Change Order Request

Williamson County Expo Center

Description	Category	Status
Wilco OCO 003 - Earthwork Revisions Per RFIs 035 & RFI 041	Pending	New

RFI #: 035

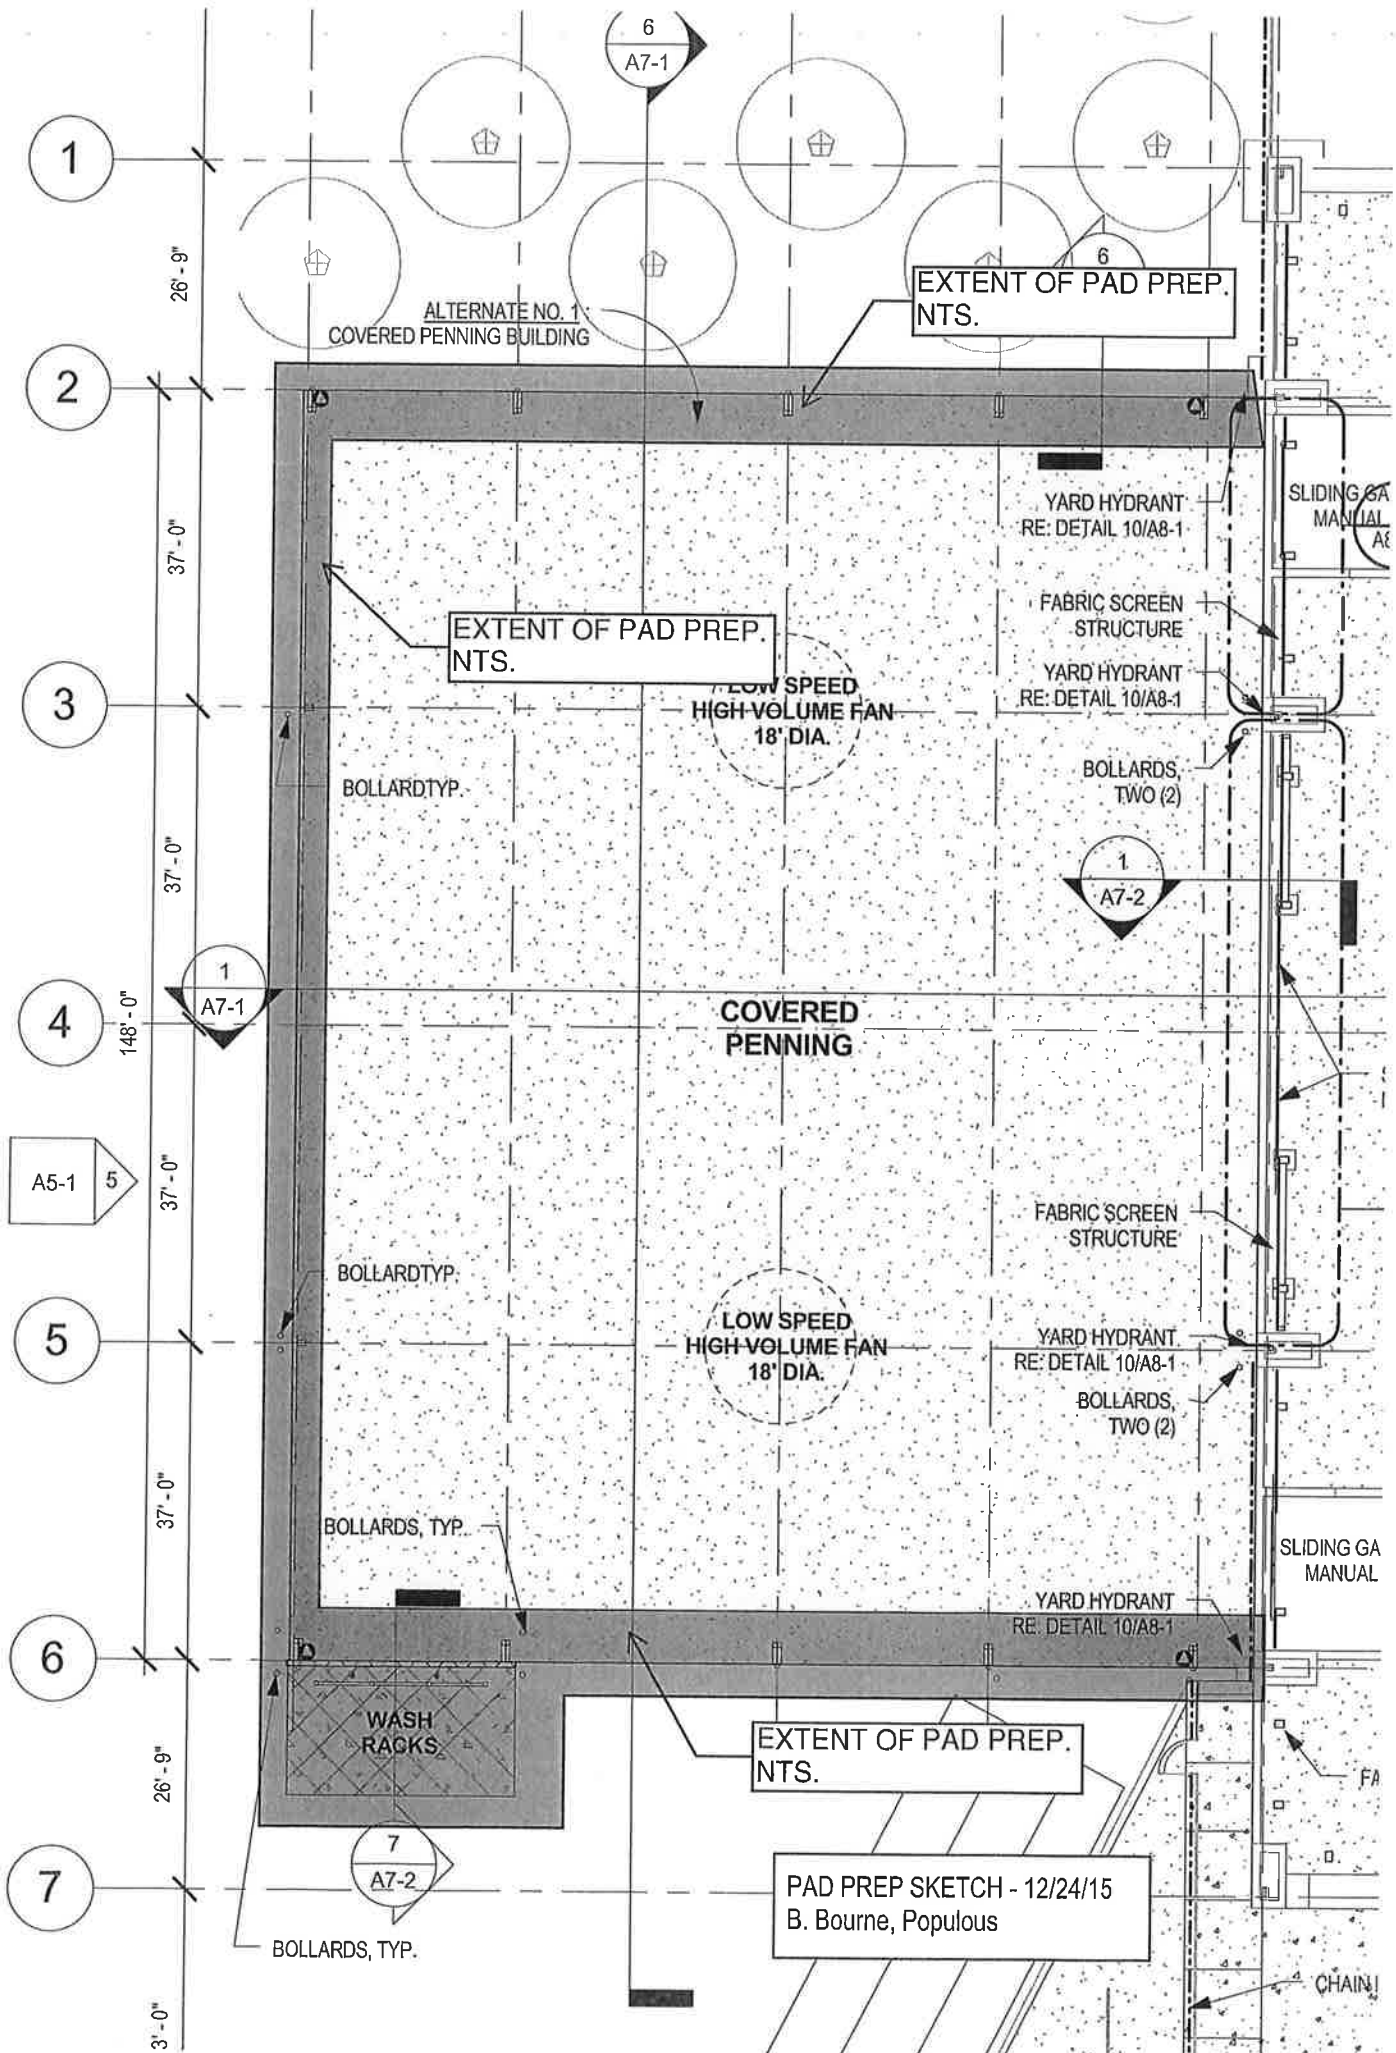
Flintco's interpretation of the pad prep requirements for the Covered Penning Alternate #1 is that the entire square foot area plus 5' overbuild would require a 5' depth excavation and replacement with select fill material. This has a significant cost implication to the owner. Please confirm Flintco's interpretation or provide a detail/clarification of the pad prep requirements at the Grade Beams/Footings

Excavation width needs to be adequate to allow equipment to work in the area to achieve the specified compaction results. Contractor needs to select the equipment that will provide the compactive effort throughout the thickness of the lift, will result in specified densities and will meet the project schedule for time. A minimum of 3 feet over build will be necessary due to the inability to sufficiently compact the edges to the specified densities.

Pad prep is only required at the Grade Beams/Footings per Engineering 360's response above.
The area to be used for livestock penning and equestrian warm-up will not require pad prep.
See attached PAD PREP SKETCH for reference.
